**Department of Transportation
Olympia, Washington 98504**

**I-405
SPRINGBROOK CREEK WETLAND AND
HABITAT MITIGATION BANK
A State Project**

Addendum No. 5

The Plans and Specifications for this project are amended as follows:

GR6
SHEET
57
OF
118
SHEETS

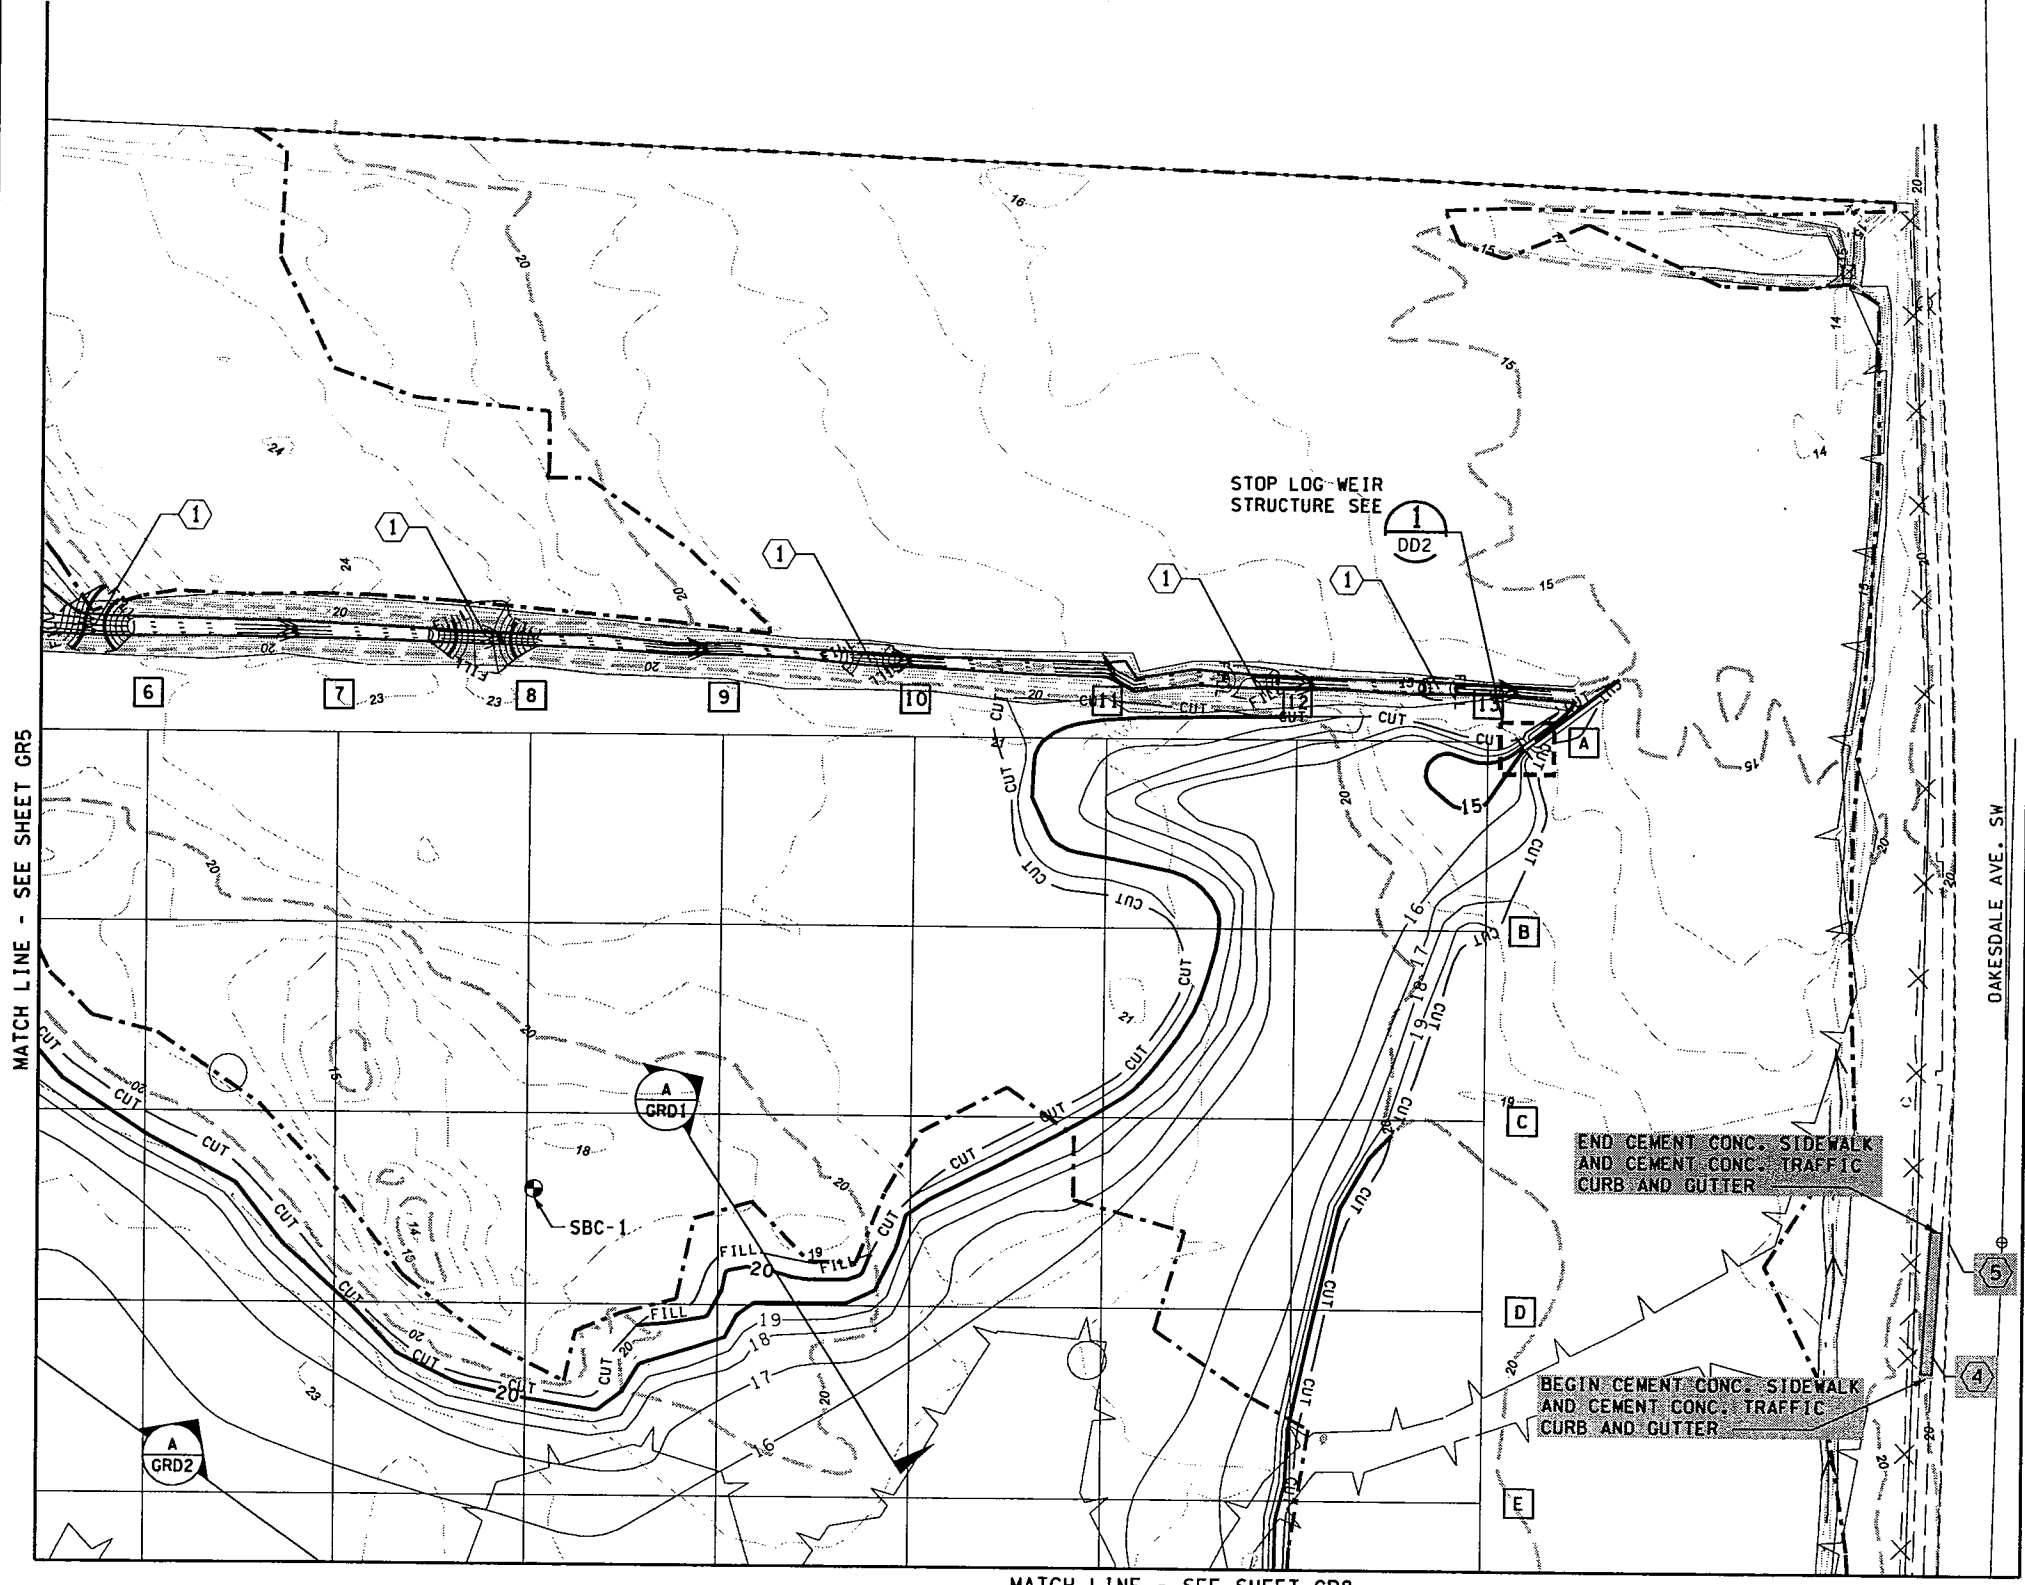
FILE NAME PW:\Engineering\010\drawings\sheets\10pp012a021d_gr06.dgn			
TIME 5:31:09 PM	ADDED SIDEWALK AND CURB AND GUTTER	09/25/06	RF
DATE 9/27/2006			
PLOTTED BY chris			
DESIGNED BY B. PETERSON			
ENTERED BY A. DEGUZMAN			
CHECKED BY R. FENTON			
PROJ. ENGR. R. FENTON			
REGIONAL ADM. D. DYE			
REVISION		DATE	BY

I-405
SPRINGBROOK CREEK WETLAND AND
HABITAT MITIGATION BANK
GR11

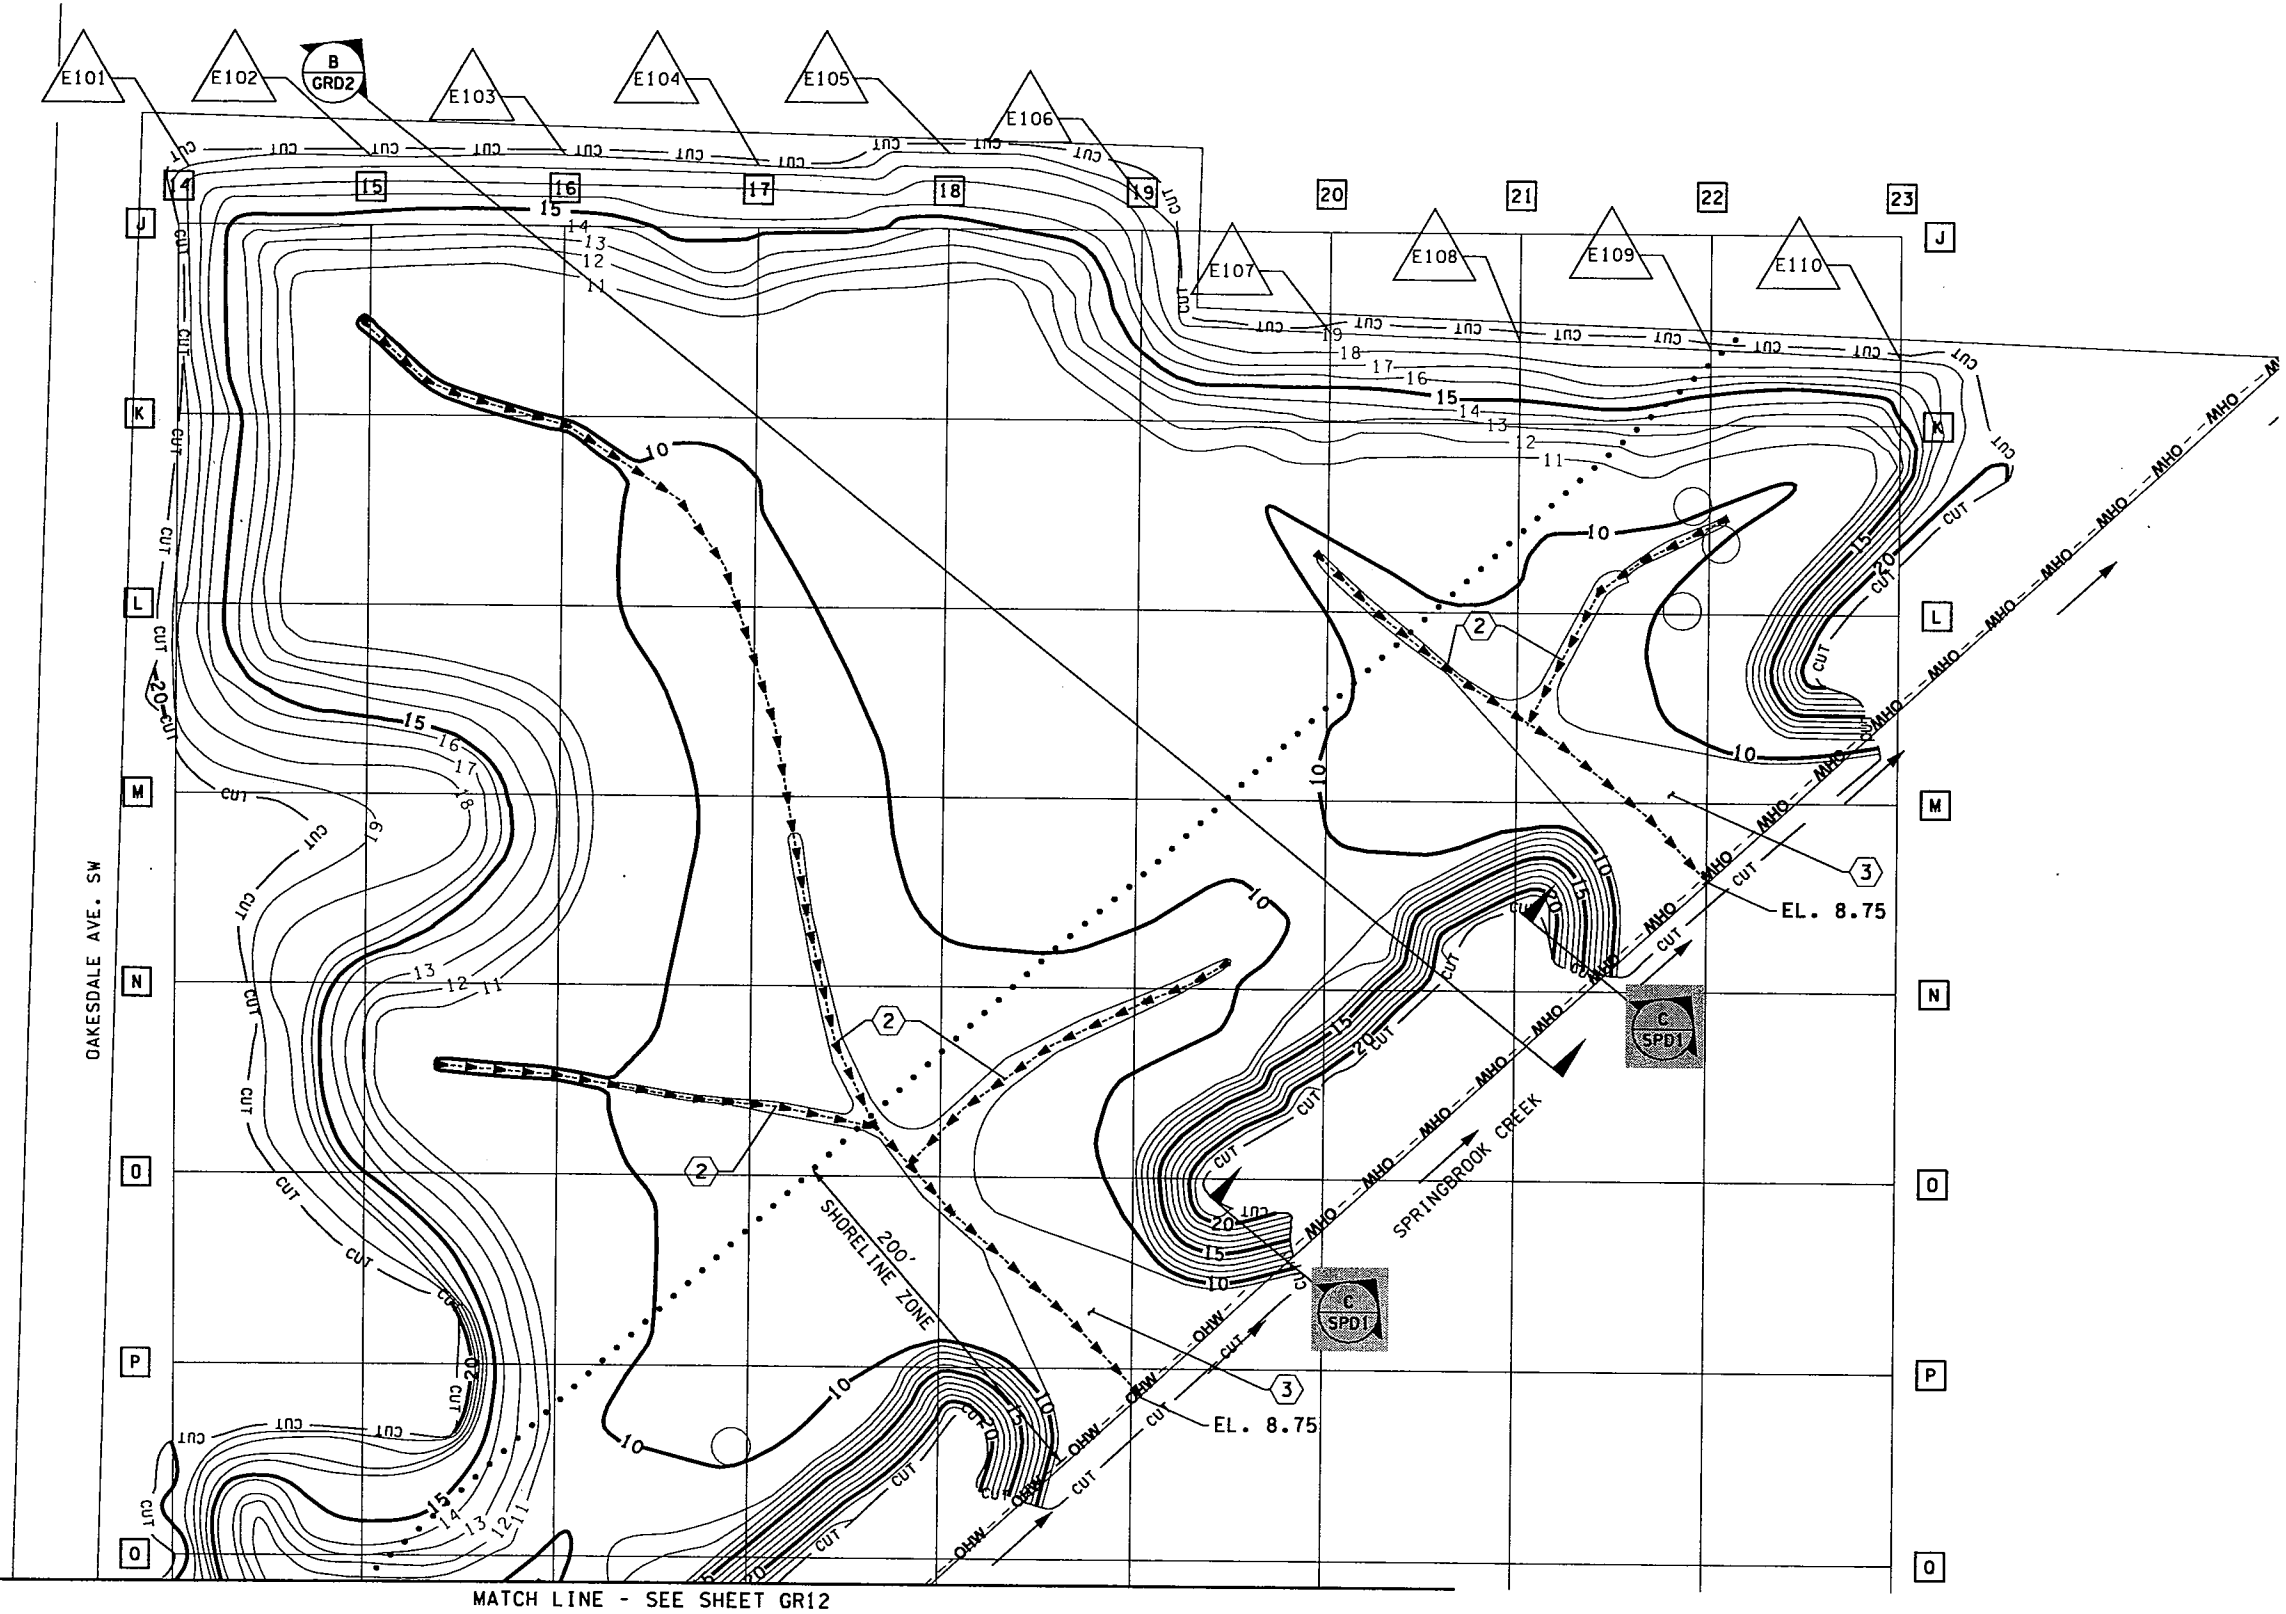
FILE NAME PW:\Engineering\010\drawings\sheets\10pp012a021d.gr11.dgn		TIME 5:31:23 PM		DATE 9/27/2006		PLOTTED BY chriss		DESIGNED BY B. PETERSON		ENTERED BY A. DEGUZMAN		CHECKED BY R. FENTON		PROJ. ENGR. R. FENTON		REGIONAL ADM. D. DYE	
ADDED SECTION C		09/25/06		RF		REGION NO. 10		STATE WASH		FED.AID PROJ.NO.		JOB NUMBER 06A805		CONTRACT NO.		LOCATION NO.	
REVISION		DATE		BY		P.E. STAMP BOX		DATE		P.E. STAMP BOX		DATE		P.E. STAMP BOX		DATE
